Addendum 6: United Nations Global Technical Regulation No. 6

United Nations Global Technical Regulation on Safety glazing materials for motor vehicles and motor vehicle equipment

Amendment 3

Paragraph 7.1.3.3., amend to read:

Figure 4
Determination of Zone I

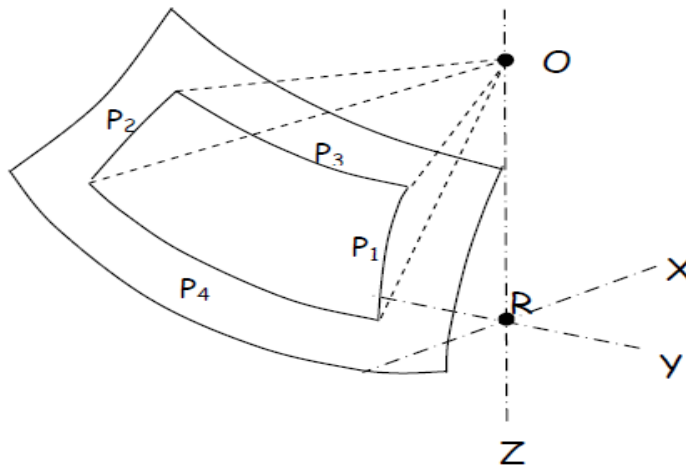
7.1.3.3.2. Zone I is the zone determined by the intersection of the windscreen with the four planes defined below:

In addition, opaque obscuration can be exempted in Zone I. It is the limited areas where it is intended that a sensing device, e.g. a rain-drop detector, rear view mirror or autonomous sensors, will be bonded to the inner side of the windscreen. The opaque obscuration where such devices may be applied is defined in paragraph 7.1.3.3.3. of this annex.

P1 a vertical plane passing through point O and forming an angle of 15° to the left of the median longitudinal plane of the vehicle;

P2 a vertical plane symmetrical to P1 about the median longitudinal plane of the vehicle.

If this is not possible (in the absence of a symmetrical median longitudinal plane, for instance) P2 shall be the plane symmetrical to P1 about the longitudinal plane of the vehicle passing through point O.

P3 a plane passing through a transverse horizontal line containing O and forming an angle of 10° above the horizontal plane;

P4 a plane passing through a transverse horizontal line containing O and forming an angle of 8° below the horizontal plane;
